## CITY OF ALEXANDRIA Project Implementation

# Waterfront Flood Mitigation Project Discussion

June 23, 2025

# AWA Alternative Concept

# AWA Alternative Concept: Gravity System & Tailwater Constraints

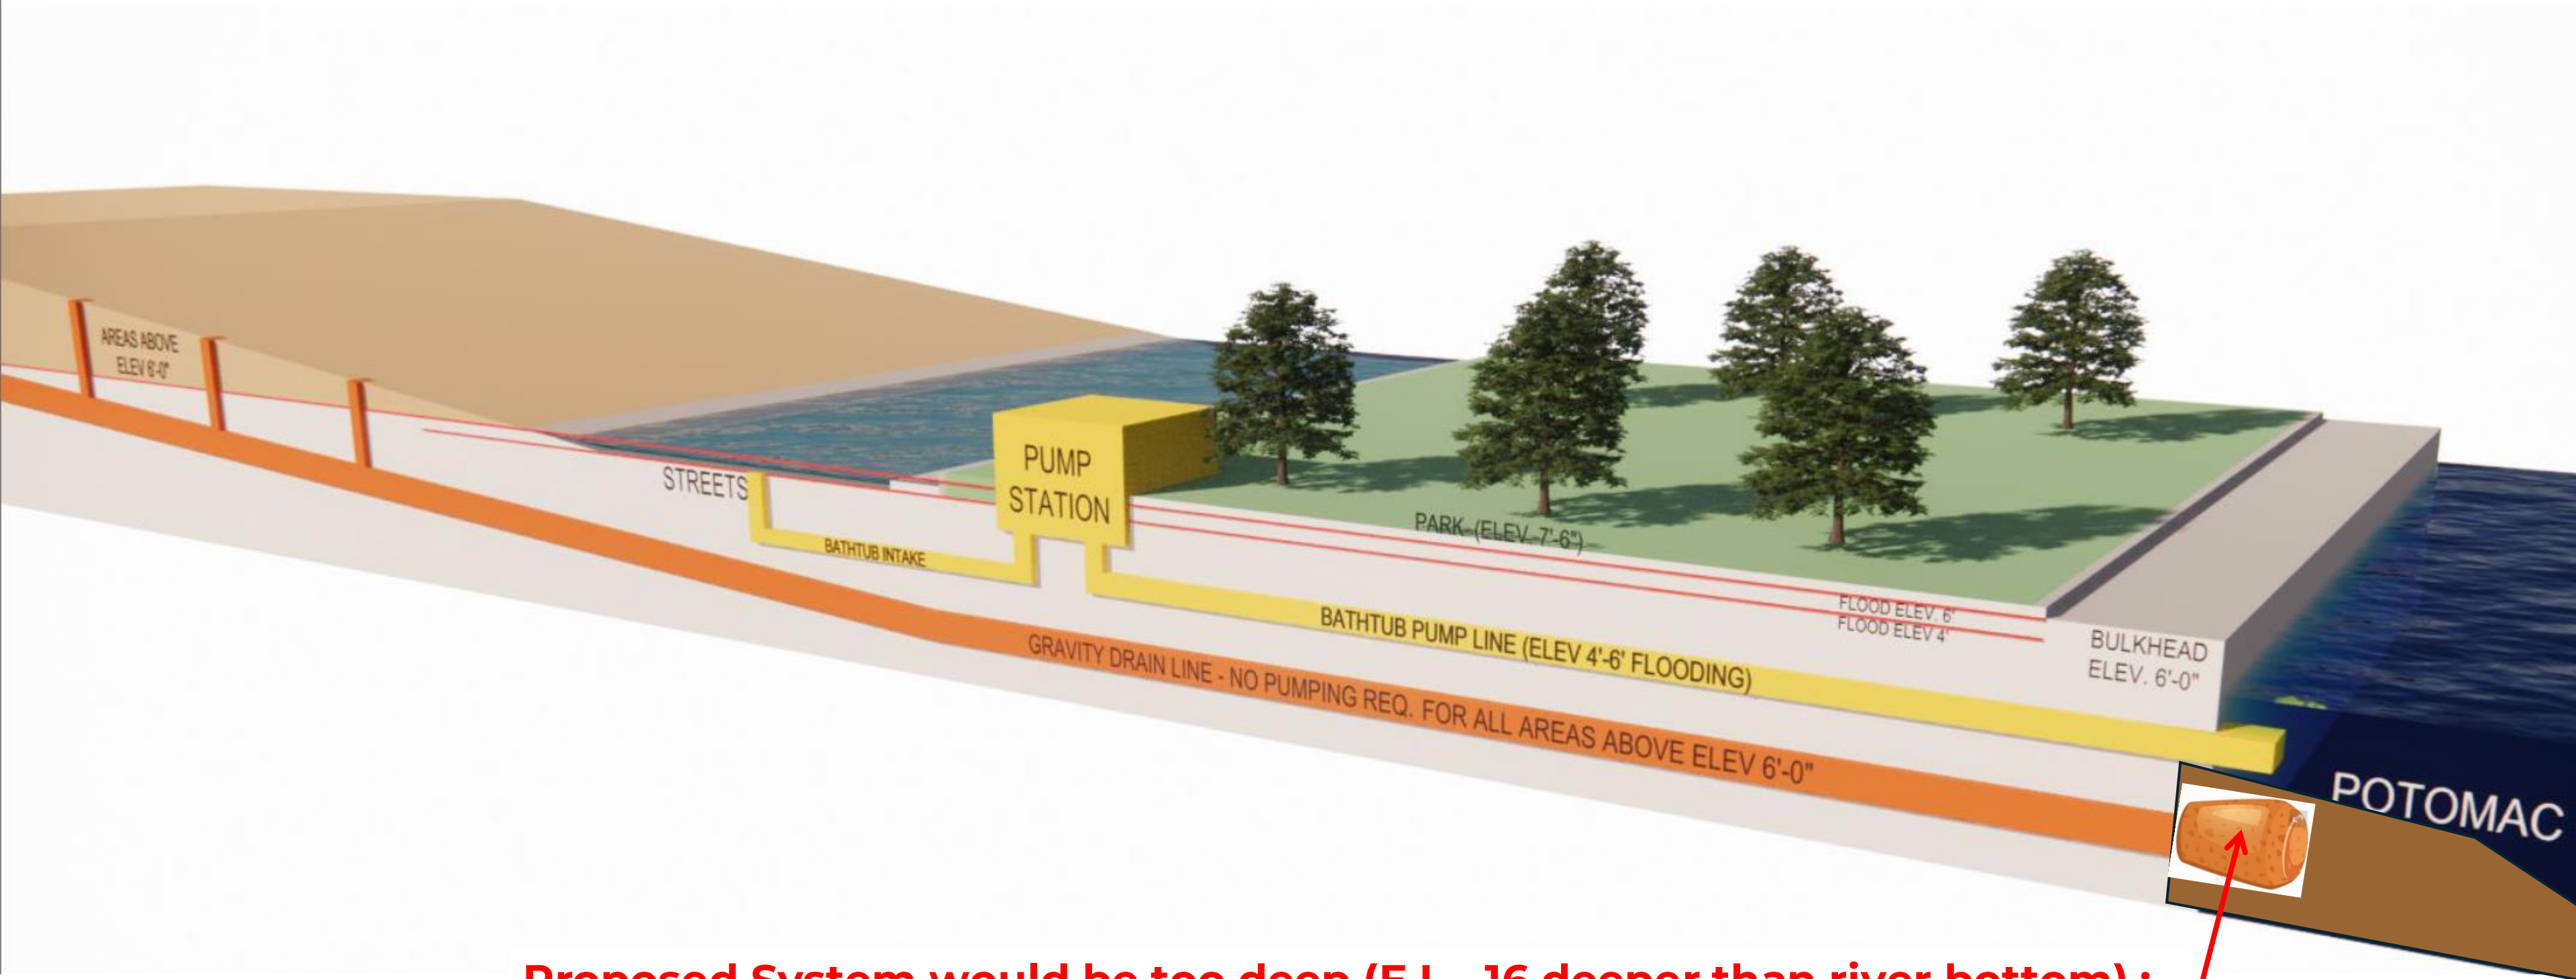
**Proposed System would be too deep (E.L. -16 deeper than river bottom):**  
**Force of Potomac River and mudline will act like a giant drain plug**

OVERALL PROJECT CONCEPT PLAN

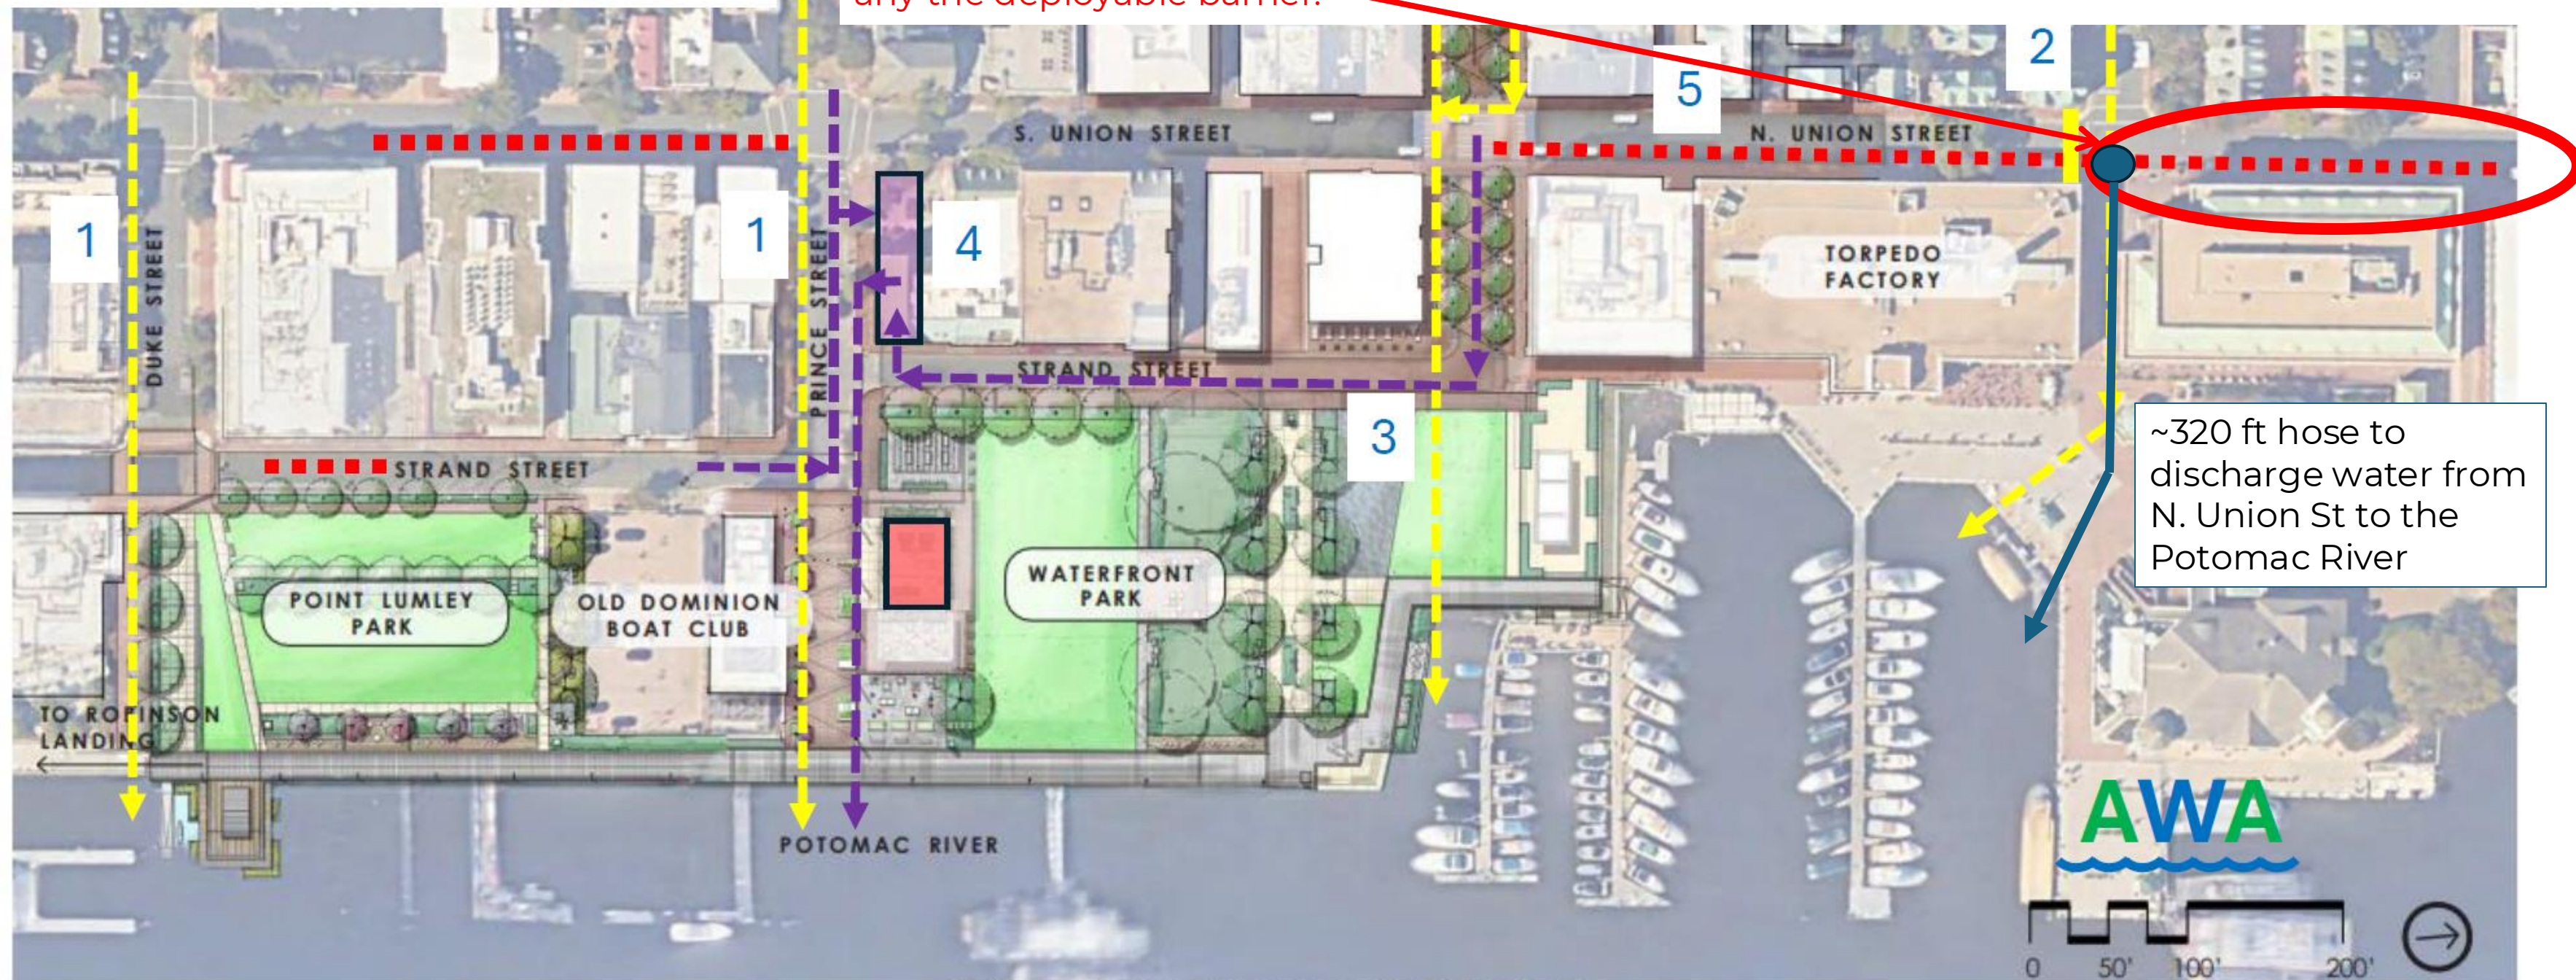
A deployable pump can be further evaluated for this location; however, it won't reduce the pump station size.

Potential that manhole at Cameron/Union intersection could be used as a point for bypass pumping.

Would require further analysis of capacity of a trailer-mounted bypass pump on Union St. Potential route for discharge hose to the Potomac River shown.

The bypass pump would need to be sized to handle the floodwater that accumulates behind any the deployable barrier.
